Alternative *SHOCK* for Armor

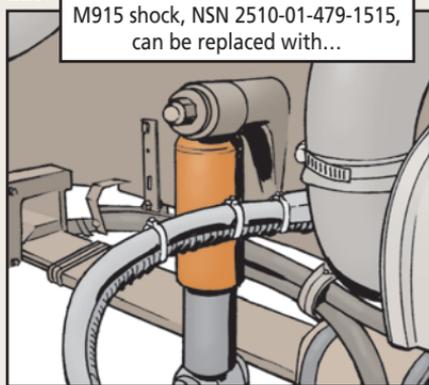
If your unit has up-armored M915A3 trucks, you may have already noticed that the front shocks, NSN 2510-01-479-1515, don't handle the added weight of the armor too well.

Some Soldiers have found busted shocks, leaking fluid and worn tires that need replacing too soon! But you can stop this.

M915 shock, NSN 2510-01-479-1515, can be replaced with...

One unit at Ft Campbell discovered that installing HEMTT shocks, NSN 2510-01-132-4983, fixed this problem. This NSN brings the upper and lower bushings and the shock. It fits right on, too, so no mods are needed. Plus, TACOM LCMC approves this.

...more durable HEMTT shock, NSN 2510-01-132-4983
